NUMBER: 23-014-13 REV. A

Sunroof Opens But Will Not Close And/Or Cycles Back To Open And/Or Sunroof Glass Scratched

This bulletin involves inspecting sunroof glass clearance and if necessary, modifying the sunroof reinforcement to allow adequate clearance for sunroof glass travel.

2012- 2013 (RT) Caravan/Town and Country

Fig. 1 Apply Tape

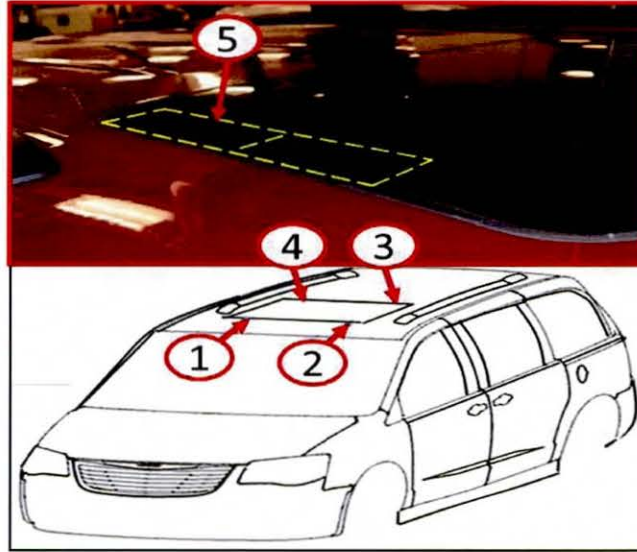
1. Adjust sunroof panel flushness along the front of the glass (1)&(2) to 2mm underflush. Adjust the rear of the sunroof glass panel (3)&(4) to zero/flush (Fig. 1).

2. Apply two pieces of felt/flock tape p/n 05019055AA to each side of the sunroof glass panel. Apply the tape end to end along the side edge of the sunroof glass panel (5) starting at the end of the rear corner radius running forward (Fig. 1).

NOTE: Once the proper glass position has been achieved, tighten the six glass panel attaching screws to 3.5 Nm (31 in. lbs.).

Fig. 2 Inspect

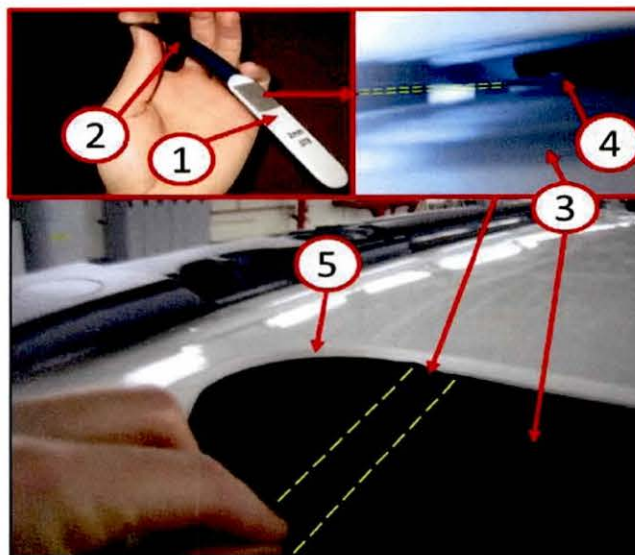
Cycle the sunroof panel to the full open position and use a 2mm feeler gage (1) to check left and right sunroof glass (3) to inner sheet metal reinforcement (4) gap. Use a flashlight to locate the lowest point between the sheet metal reinforcement (4) and sunroof glass (3) (Fig. 2).

-
3. Is the clearance between the inner sunroof sheet metal reinforcement and sunroof glass 2mm or greater?
 - a. Yes>>> This bulletin does not apply, further diagnosis required.
 - b. No>>> Cycle the sunroof to the fully closed position and remove the felt/flock tape. Proceed to [Step #4](#).
 4. Remove the sunroof module. Refer to the detailed procedures available in DealerConnect> TechCONNECT under: Service info> 23-Body> Sunroof> SUNROOF> Removal.

Fig. 3 Modify Using Special Tool

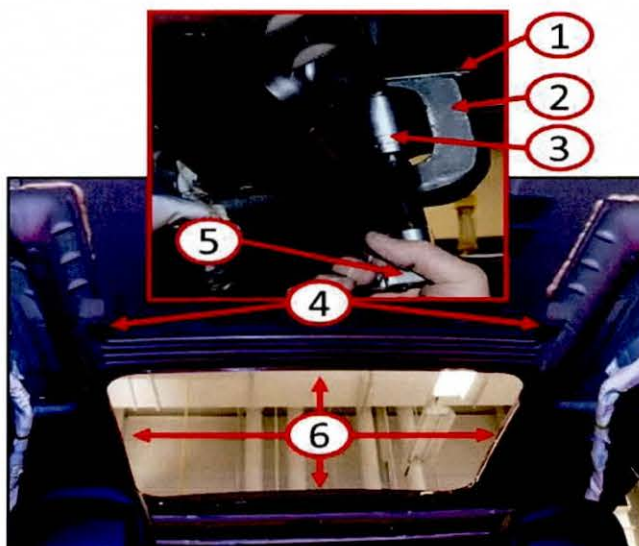
5. Using a backer plate (1) or heavy (3/8"/10mm minimum thickness) cardboard to protect and disburse any pressure applied against the outer roof sheet metal, insert the C-4150A ball joint press/special tool (2) into the low hanging sunroof reinforcement feature (4) (Fig. 3).
6. Insert a 30mm socket or equivalent (3) between the sunroof reinforcement and spindle of the C-4150A ball joint press/special tool to take up space between the frame and spindle of the press. Carefully tighten the spindle of the press to compress the center of the sunroof reinforcement upward (Fig. 3).

Fig. 4 Verify Modification

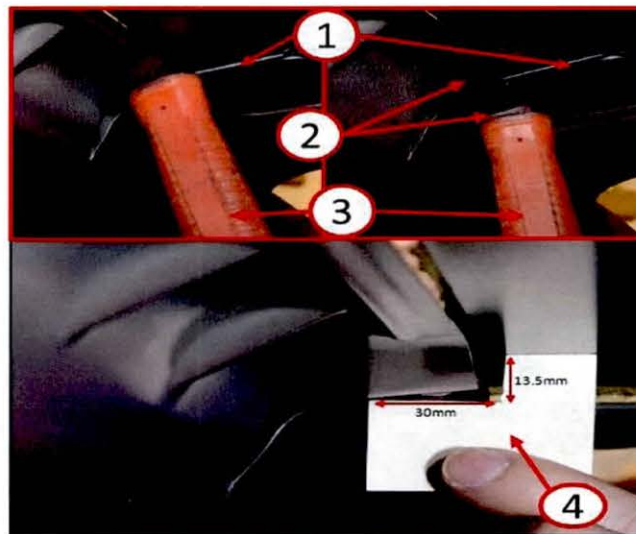
7. Using a backer plate (1) or heavy (3/8"/10mm minimum thickness) cardboard to protect and disburse any pressure applied against the outer roof sheet metal, carefully push the remaining left and right side of the low hanging sunroof reinforcement feature (2) upward using a hammer handle or equivalent blunt tool (3) to provide additional clearance (Fig. 4).

WARNING:A backer plate must be used to protect the exterior roof sheet metal panel from deformation and evenly disburse any pressure placed on the exterior roof panel. Failure to do so will result in damage to the outer roof panel as the raised center of the reinforcement will contact the outer panel creating a dimple or dent from focused pressure at the point of contact.

8. Using an index card or folder stock, create a verification gage (4) that will ensure the proper clearance is achieved as a result of modifying the sunroof reinforcement. The gage should measure 13.5mm down from the outer roof panel and 30mm inward from the outer edge of the sunroof reinforcement. Move the verification gage back and forth along this area to ensure proper clearance is achieved (Fig. 4).

NOTE: Repeat the modification procedure for the opposite side of the vehicle or on existing side until desired clearance is achieved.
